**HISTORIC PRESERVATION REVIEW BOARD
STAFF REPORT AND RECOMMENDATION**

Landmark/District: **Mount Pleasant Historic District** (x) Agenda
Address: **3118-3120 16th Street NW**

Meeting Date: **November 19, 2015** (x) Addition
Case Number: **16-054** (x) Alteration
(x) Subdivision
Staff Reviewer: **Tim Dennée** (x) Concept

The applicant, Jennifer Birks (R. Michael Cross Design Group), architect and agent for the contract purchaser, Pleasant 16th LLC, and with the consent of the property owner, Neighbors Consejo, requests the Board’s review of a concept to combine two buildings—which will require a subdivision—and to construct roof and rear additions and undertake some demolition toward those ends.

Subdivision

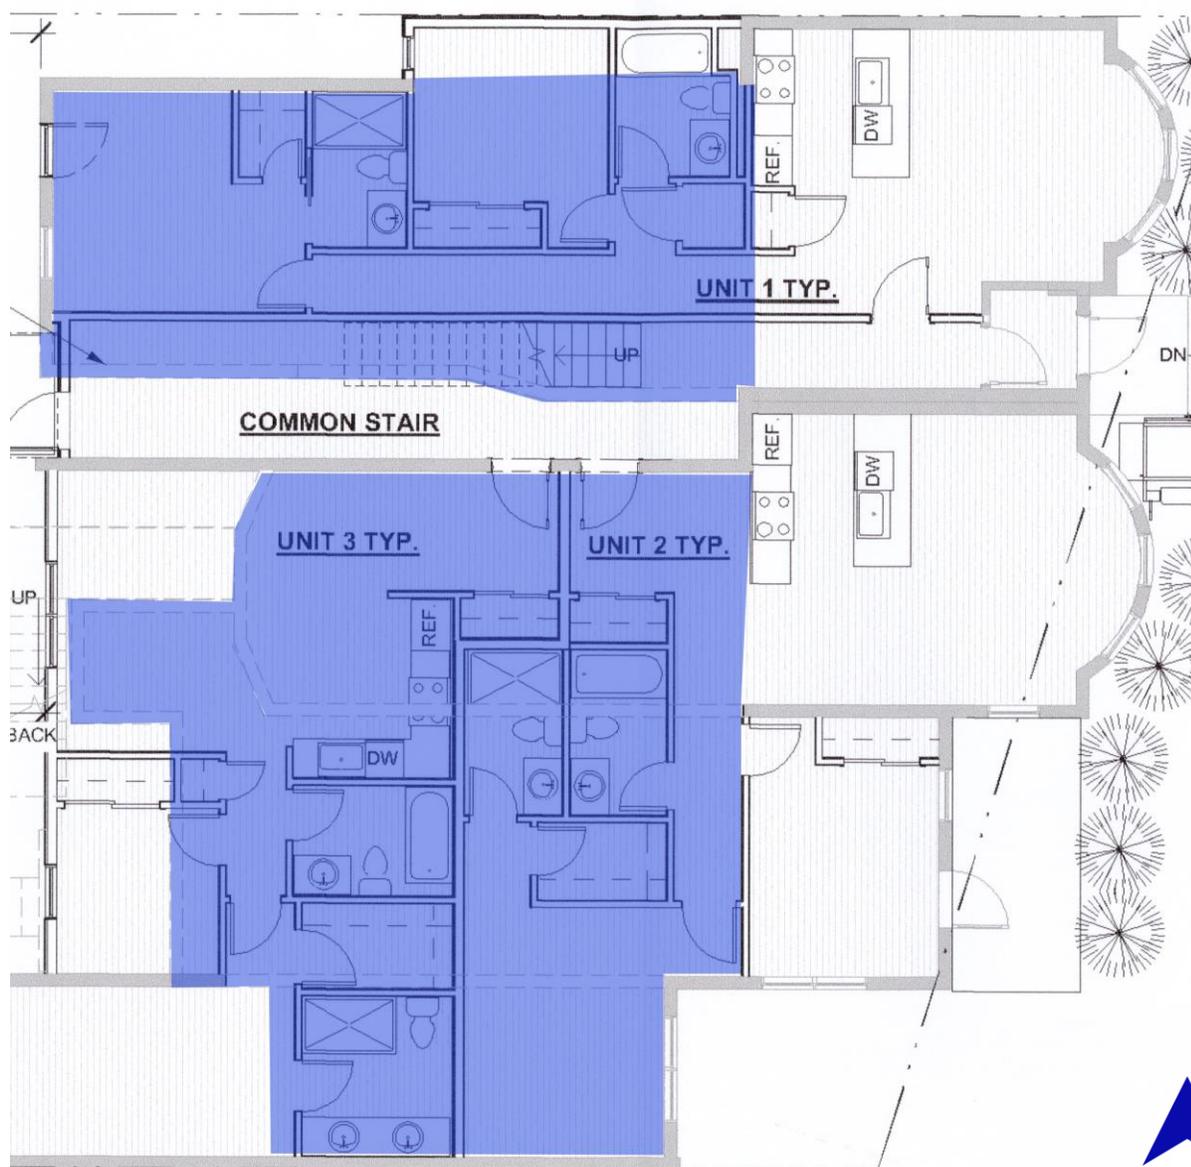
Subdivision to consolidate the two lots would be necessary to connect the houses, as well as to create a lot of record. The compatibility of the subdivision of the lots depends upon the compatibility of the projects it makes possible. With the two houses present, there remains little additional developable area, whether they are connected or remain separate. As always, if the amount and character of the demolition necessary to achieve the connection is reasonable, then the combination itself could be found compatible.
